## Meeting Agenda Plat Committee

Monday, October 11, 2021

1. [KPB-3597](#) Alaskan Wildwood Phase 2  
KPB File 2021-127  
*Attachments:* [1. MAP Vicinity](#)  
[2. MAP Aerial Map Zoomed In](#)  
[3. Plat Prelim KPB 2021-127 Reduced](#)  
[4. Staff Report Alaskan Wildwood Phase 2 KPB 2021-127](#)  
[5. MAP Aerial 3](#)  
[6. MAP Aerial Map Zoomed Out](#)  
[7. MAP Contour](#)  
[8. MAP Section Line Easement](#)  
[9. MAP Wetlands](#)  
[10. Plat Parent HM 2000-48](#)  
[11. Plat Parent HM 2000-31](#)
2. [KPB-3598](#) ASLS No. 2017-23 Tract A B C D & E  
KPB File 2021-133  
*Attachments:* [1. MAP Vicinity](#)  
[2. MAP Aerial](#)  
[3. Plat Prelim KPB 2021-133 Reduced](#)  
[4. Staff Report ASLS 2017-23 Tracts A-E 2021-133](#)  
[5. Plat Parent SW2001-10](#)  
[6. Plat parent SW 1998-03](#)

SURVEY DATE: JUNE 16, 2021	DRAWN BY: AK
SHEET: 2 OF 2	CHECKED BY: BS
PROJECT NO.: 21024	SCALE: 1" = 200'

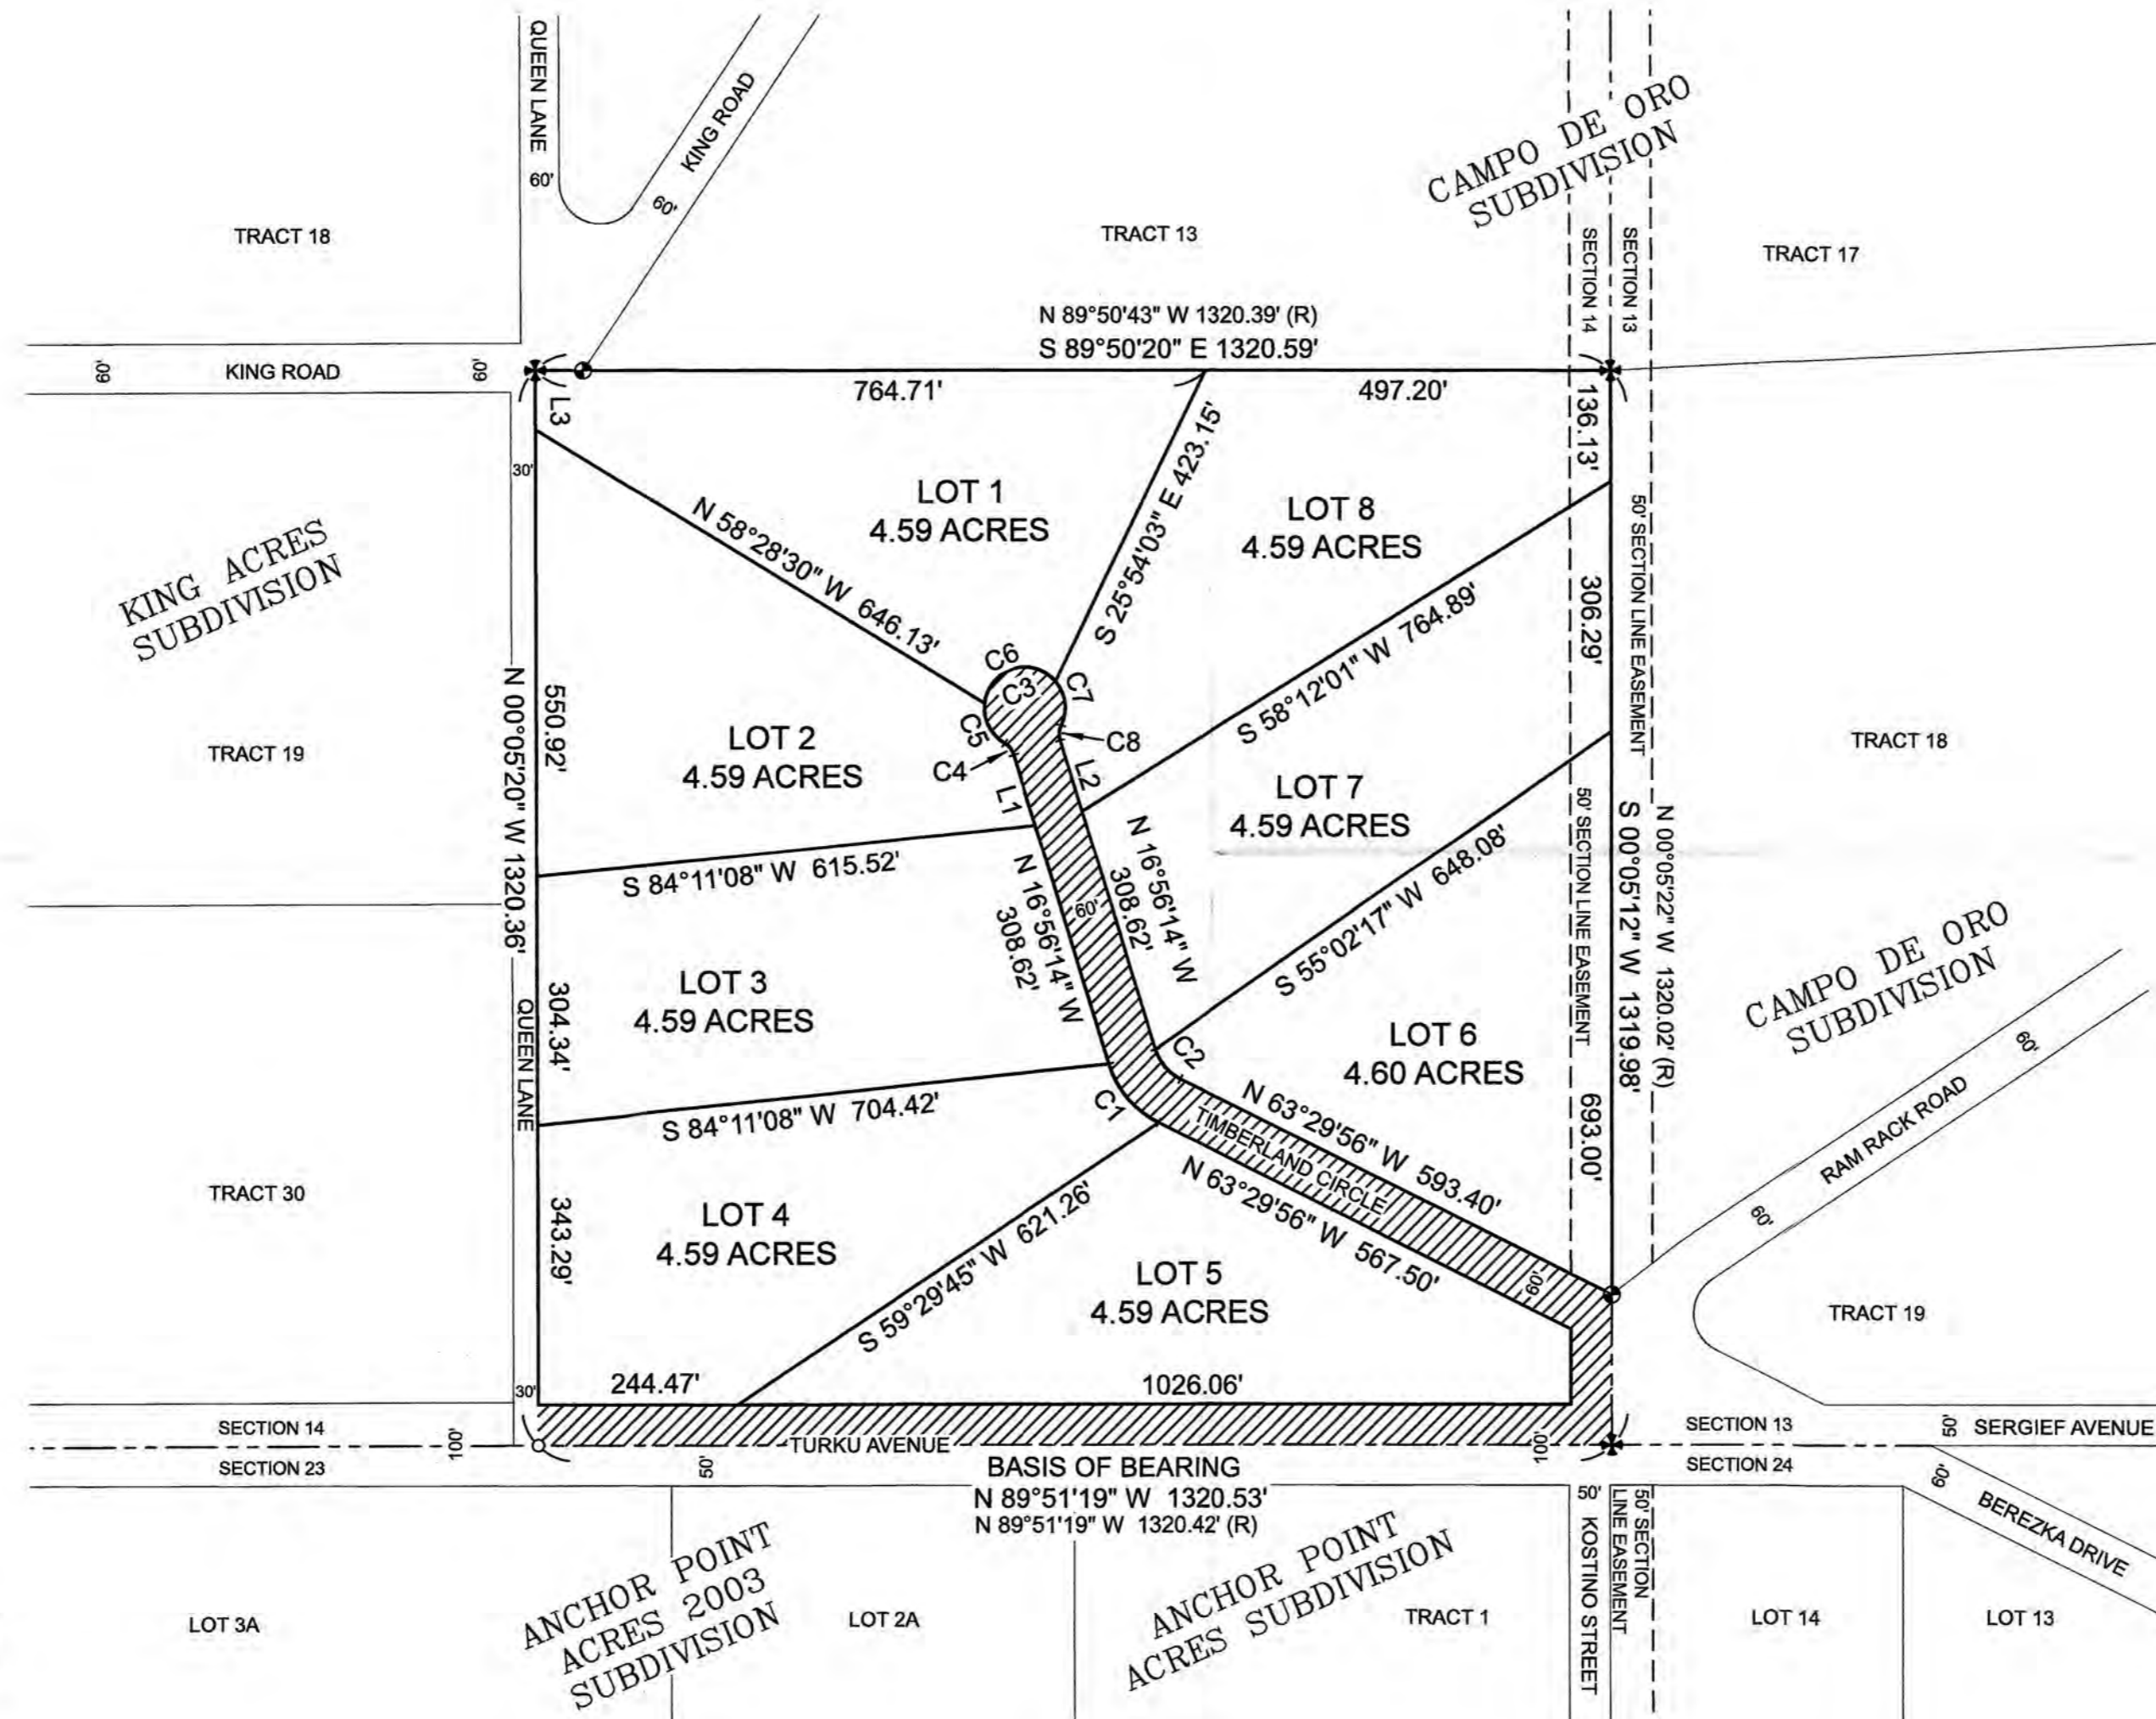
- Update the subdivision name to Alaskan Wildwood Subdivision. Phase is a designation used for a portion of a larger approved plan where portions are finalized at different times.

- Provide the KPB file number (2021-126) near or within the title block.
  - Within the title block remove the reference to Document No. 2019-002734 as that is a deed and not a document that created the parcel of land.

- Provide the owners name and mailing address within the title block.
  - Update the sheet to 1 of 1.
- C. The location, width, and name of existing or platted streets and public ways, railroad rights-of-way, and other important features such as section lines or political subdivisions or municipal corporation boundaries abutting the subdivision;

**Staff recommendation:** Label all section line easements within and abutting the subdivision such as the one within Section 19. Provide a street name label and right of way width for Kluchevaya Street.

**Staff recommendation:** *The hatching used on the plat is typically used to depict vacations. No hatching is required for ROW dedications. Provide labels that state ROW being dedicated this plat. Update to the subdivision boundary to show the parent parcel as the boundary.*

**Staff recommendation:** *The label to the south should be updated to Kluchevaya Village Subdivision Amended.*
- H. Approximate locations of low wet areas, areas subject to inundation, areas subject to flooding or storm water overflow, and the line of ordinary high water. This information may be provided on an additional sheet if showing these areas causes the preliminary plat to appear cluttered and/or difficult to read;

**Staff recommendation:** *Per KPB GIS data, the northwest corner may contain wetlands. Verify during the field survey and depict and label any low wet areas that affect the subdivision.*

**Staff recommendation:** *Provide a minimum 30 foot dedication along the eastern boundary for the extension of Some Road.*

**Staff recommendation:** *Within the drawing, depict and label the 20 foot building setback.*
